THUNDERBIRD OFFICE PARK
AN ADDITION TO WICHITA, SEDGWICK COUNTY, KANSAS

RE: SUB 2001-109 -- Final Plat of Thunderbird Office Park Addition

At the regular meeting of the Subdivision Committee of the Metropolitan Area Planning Commission on Thursday, December 13, the above captioned plat was considered. The action of the Committee was to approve the final plat, subject to the following:

CASE NUMBER: SUB 2001-109 – THUNDERBIRD OFFICE PARK ADDITION

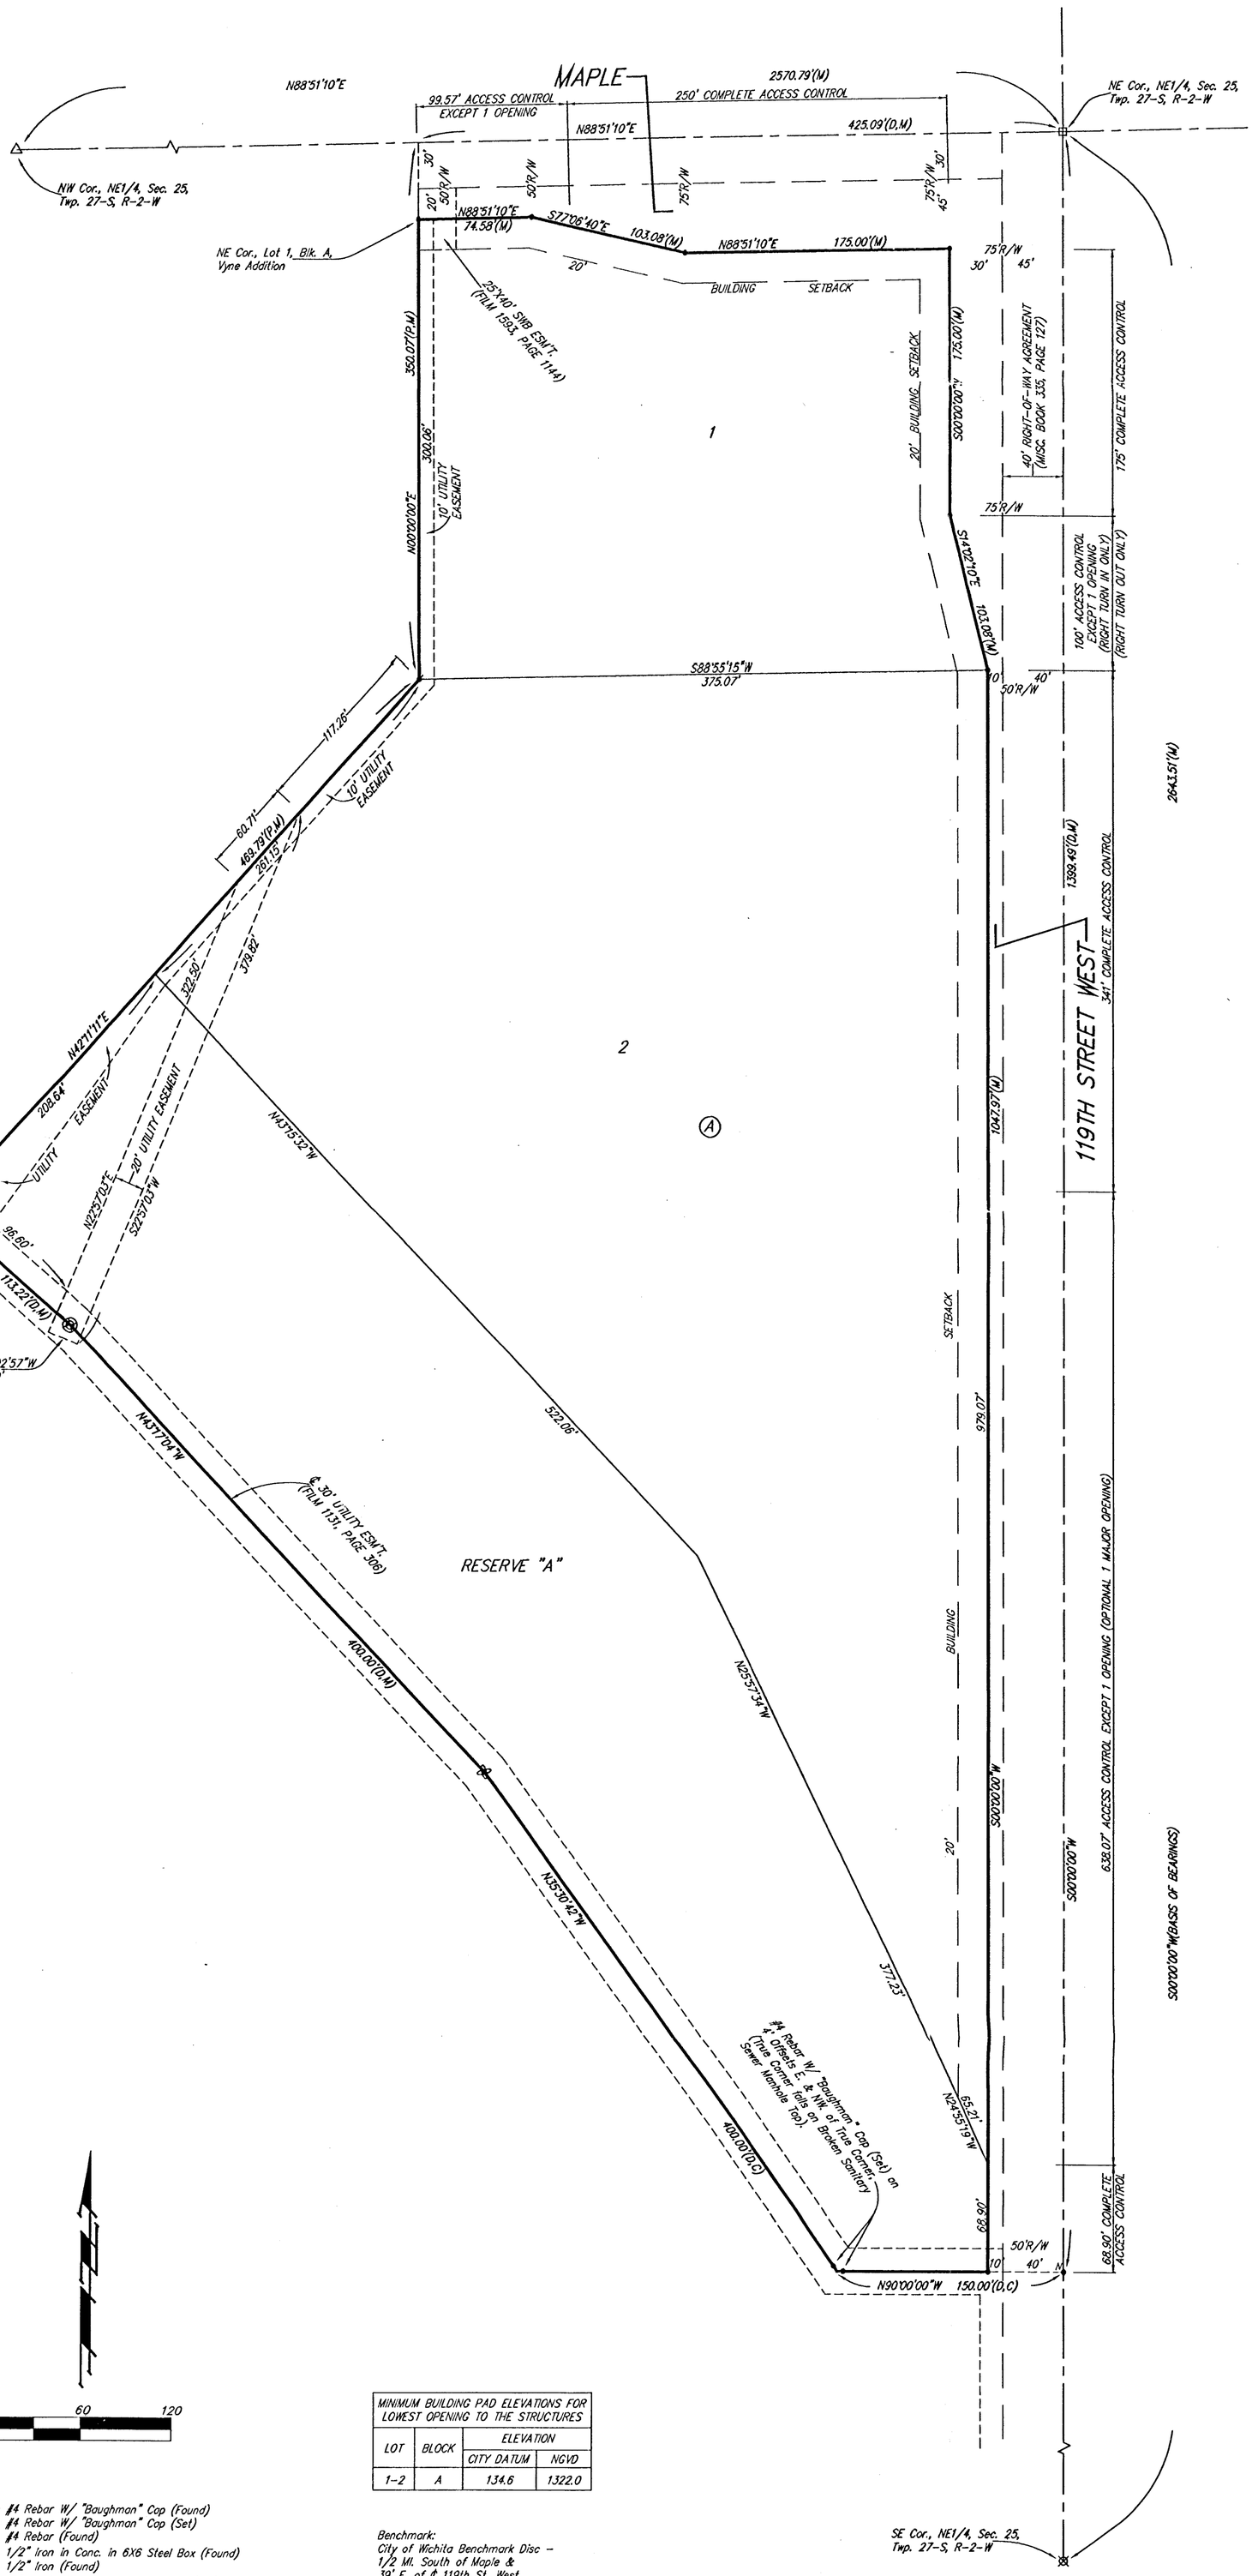
D. County Surveying has advised that the sanitary sewer easement needs to be located.

E. A dimension is needed along the south line of Reserve A.

F. The plat proposes two access openings along 119th St. West and one opening along Maple. *The northerly opening may be retained subject to right turns only and construction of a median extension. A cross-lot access agreement shall be provided between Lots 1 and 2.*
